CITY OF
TUCSON

PLANNING AND
DEVELOPMENT
SERVICES
DEPARTMENT

September 20, 2016

SUBJECT: Banner University Medical Center Planned Area Development (PAD- 28),
Minor Amendment – Central Utility Plan Relocation

Enclosure 1: Central Utility Plant location change from location shown in PAD Appendix C, Page 191-192: “Illustrative Site Plan”

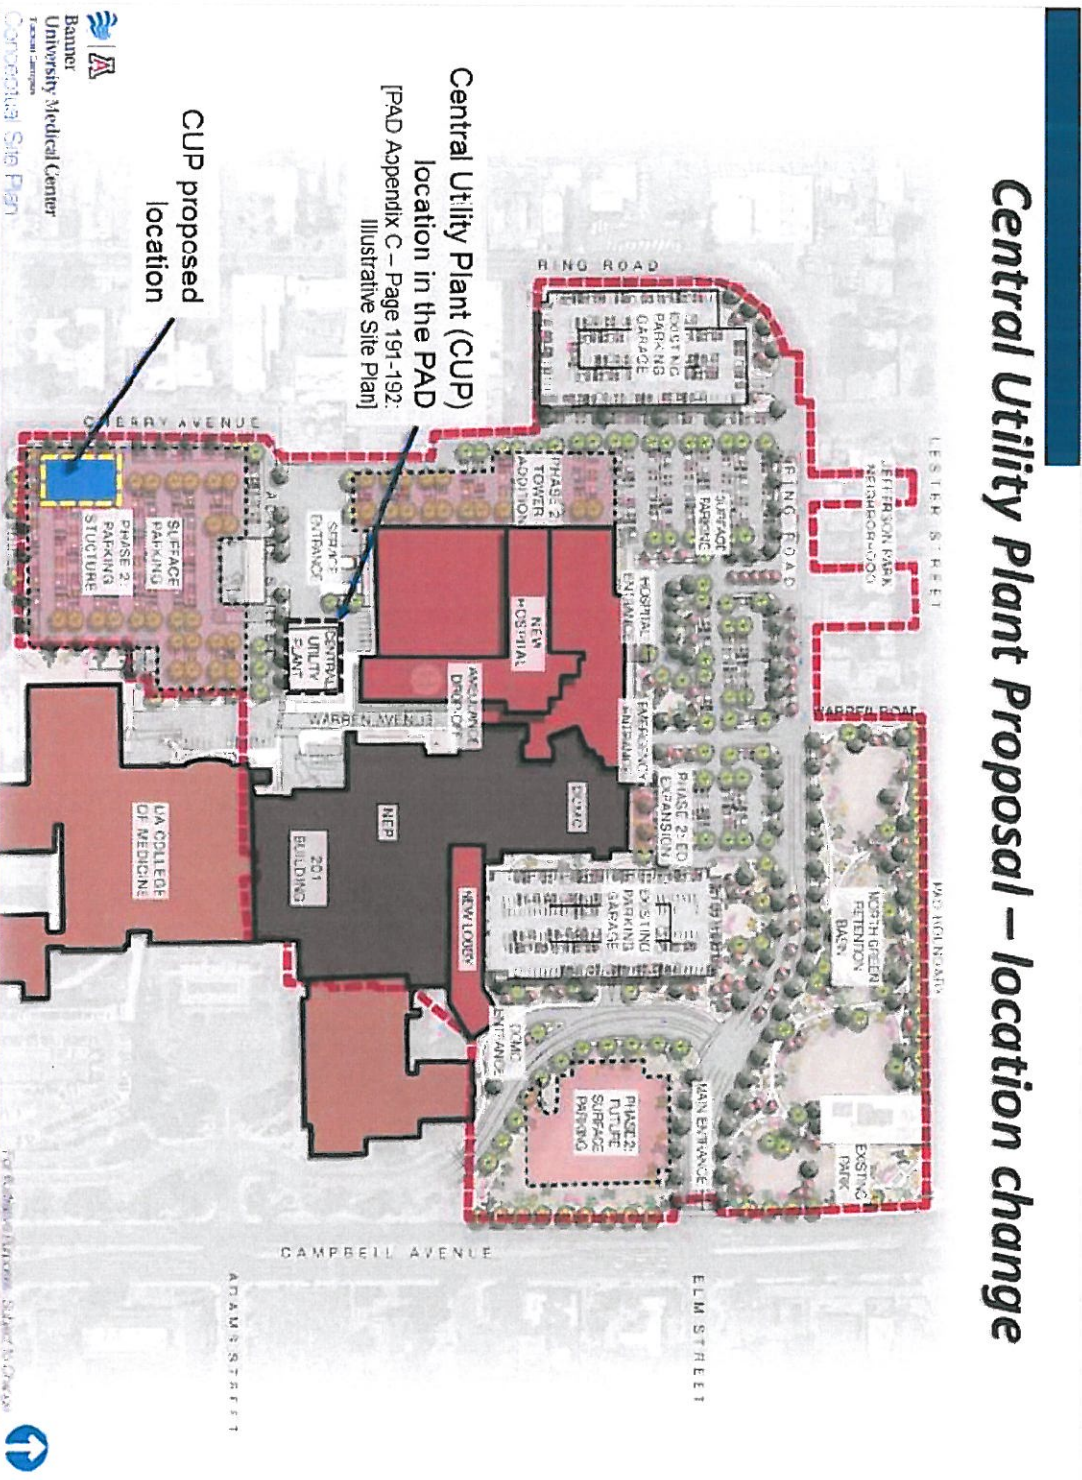
PAD-28 contemplated the CUP’s location in two possible areas, each south of the new hospital expansion and near Adams St. *See Enclosures 1 and 2*. Further engineering and site analysis has determined the best location for the CUP is at the northeast corner of Cherry and Drachman. *See Enclosure 3*. This location is in the general vicinity of the two locations shown in PAD-28, and just south of the location proposed in the PAD’s utility site plan. This location change is a minor adjustment to the original CUP sites contemplated by the PAD.

Enclosure 4: Central Utility Plant site plan showing the above ground storage tank (AGST) yard

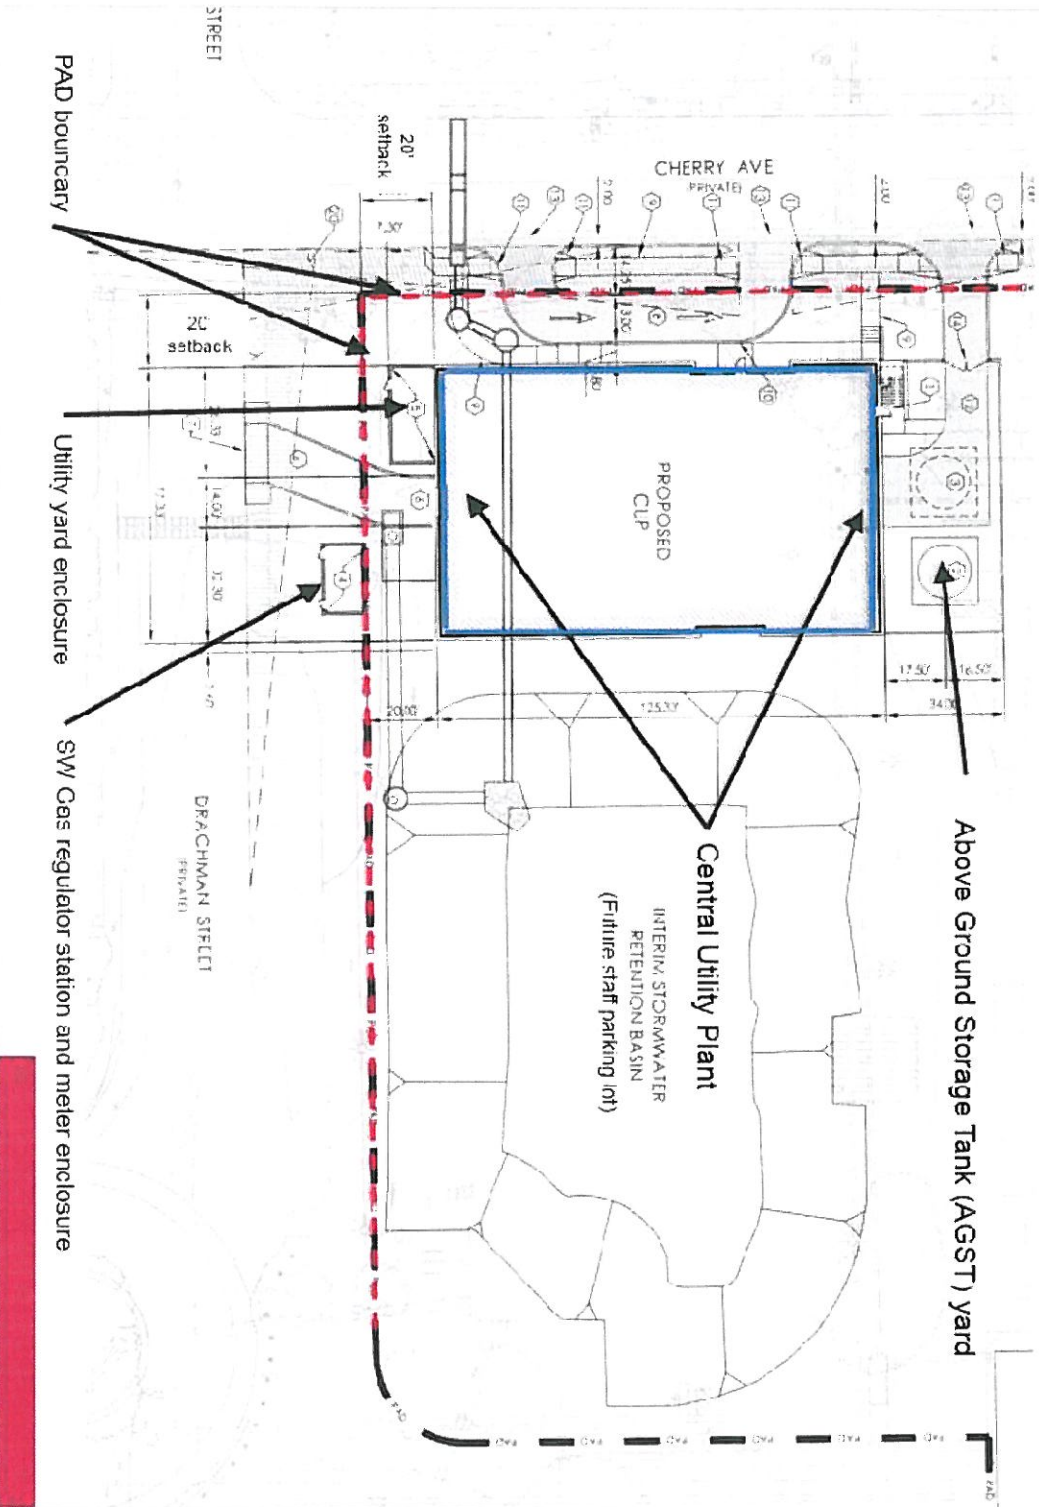
location will also include above-ground storage tanks (“AGST”) containing diesel fuel for the backup generators. *See Enclosure 4* (CUP Site Plan).

Enclosure 5: Central Utility Plant building setbacks

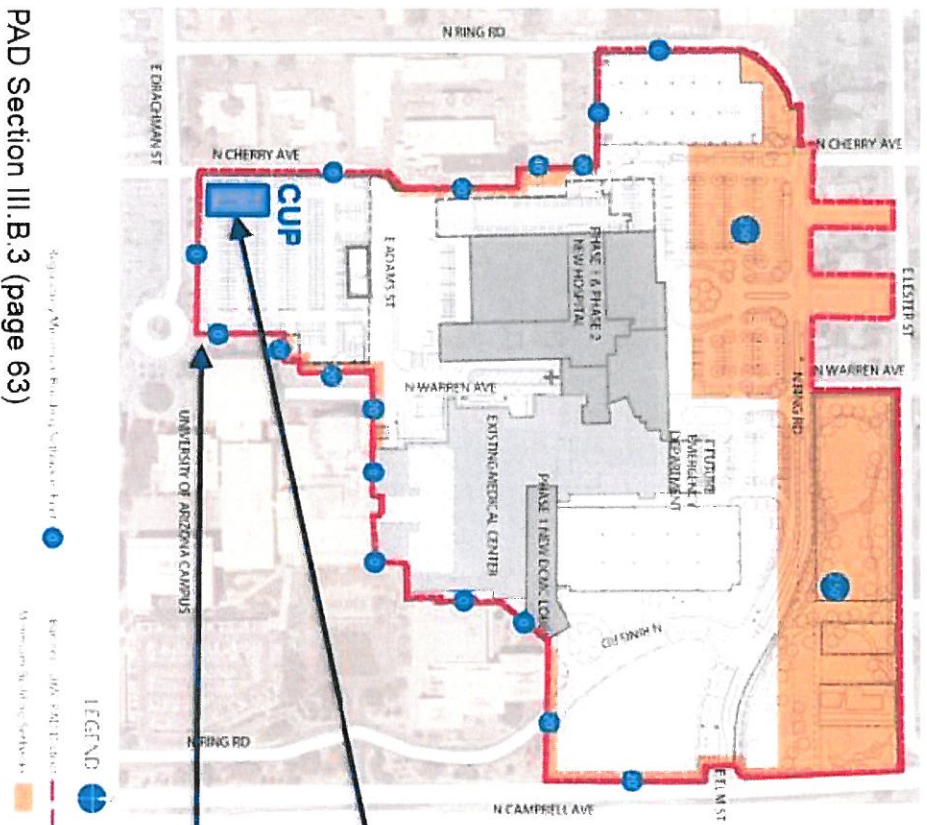
PAD-28, Section III.B.3.A (page 61) requires a 20-foot setback for all buildings or structures erected after the rezoning’s effective date. This setback is measured from both the exterior PAD boundary and the edge of any public right-of-way or private roadway internal to the PAD. The CUP will comply with these setbacks, as shown on **Enclosure 5**. There

potentially will be a screened water backflow preventer and gas meter that could be located within the setback area. In our meeting, Mr. Beall indicated this screened mechanical equipment can be located within the 20-foot setback area. As part of this determination, we ask that you confirm this.

CUP proposed location will be setback 20' from the west and south PAD boundary as well as at least twenty feet (20') from the edge of any public right-of-way or from any private roadway internal to the PAD District = **COMPLIANT**

New surface parking lot and future parking structure will be setback 0' = **COMPLIANT**

PAD-28 Section III.B.3.A requires a 20 foot setback for all building or structures erected after the rezoning date. The CUP will comply with these setbacks, as shown on Enclosure 5. There potentially will be a screened water backflow preventer and gas meter that could be located within the setback area. This letter also confirms that the proposed CUP screened mechanical equipment can be located within the 20 foot setback area (See Enclosure 5). A copy of this letter, including your request letter and exhibits must be attached to any development package submittal.

Enclosure 7: PAD District parking adjustments for the CUP

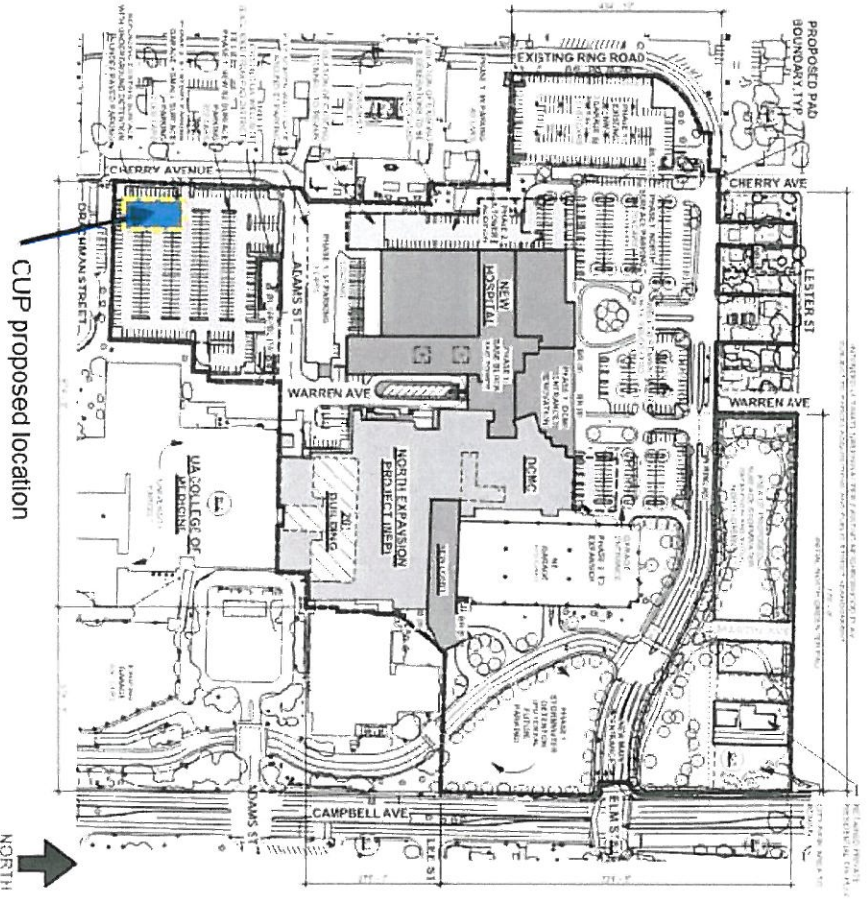
Phase 1 of the B-UMCT expansion will provide 2,662 parking spaces, which falls within the range required by PAD-28. *See Enclosure 7, Parking Adjustments for the CUP.* At the time Banner completes phase 2, it will adjust B-UMCT's parking to comply with the PAD-28 parking requirements – based on the new hospital bed count and area.

NOTE: The updated parking count for Phase 1 with the CUP is will in the PAD criteria range = **COMPLIANT**
